ALERT SERVICE BULLETIN

212-20-164

20 November 2020
Revision A, 17 December 2020

SUBJECT: FUEL CHECK VALVE P/N 209-062-607-001,
INSPECTION AND REPLACEMENT OF.

Figure 3. Fuel Check Valve Outside Diameter Measurement

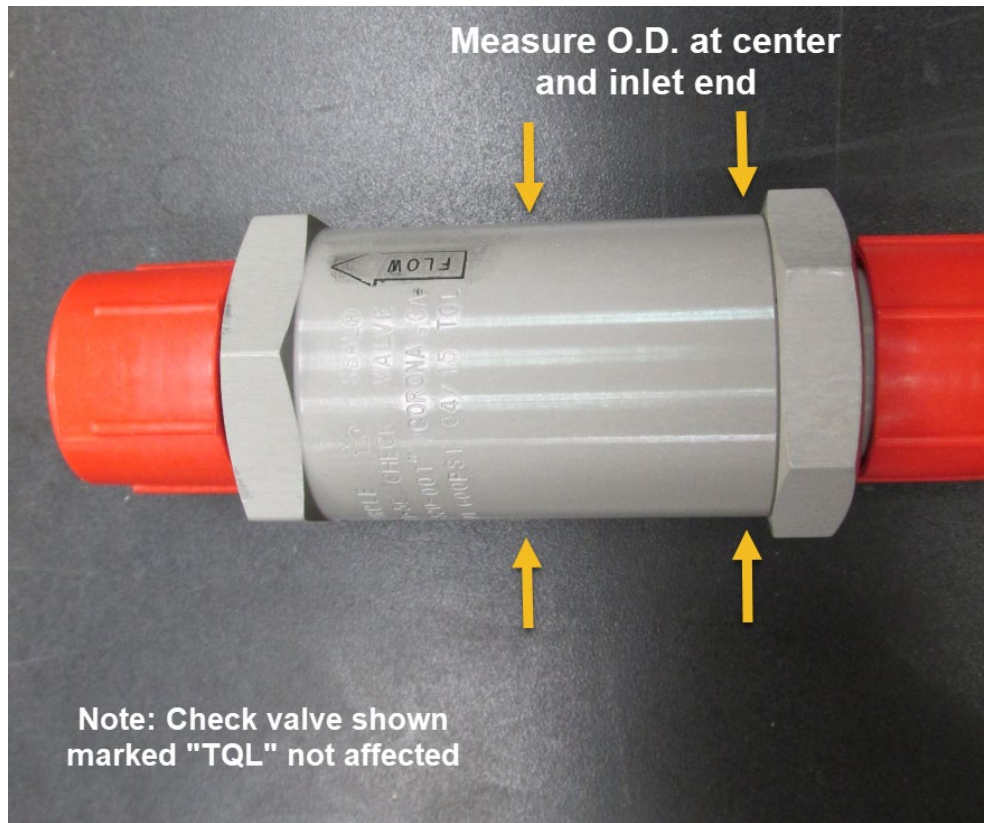
- d. If the dimension measured at the inlet end is greater than 0.003 inch (0.0762 mm) when compared to the measurement at the center, the valve will require

1. Prepare the helicopter for maintenance and gain access to the fuel check valves (Figure 1).
2. Using a strong light source, visually inspect the fuel check valves for general condition and fuel leaks. Inspect for cracks at the inlet end where the threaded fitting is installed (Figure 3).
3. If a crack is found, replace the check valve prior to next flight. Figure 4 shows an example of a cracked check valve.
4. If no cracks or any other defects that would cause the valve to be unserviceable are found, make an entry in the helicopter logbook and historical service records indicating the findings and that Part II will require accomplishment until Part III is accomplished.

replacement. Part III can be accomplished immediately, or Part II can be accomplished until the defective valve can be replaced in accordance with Part III.
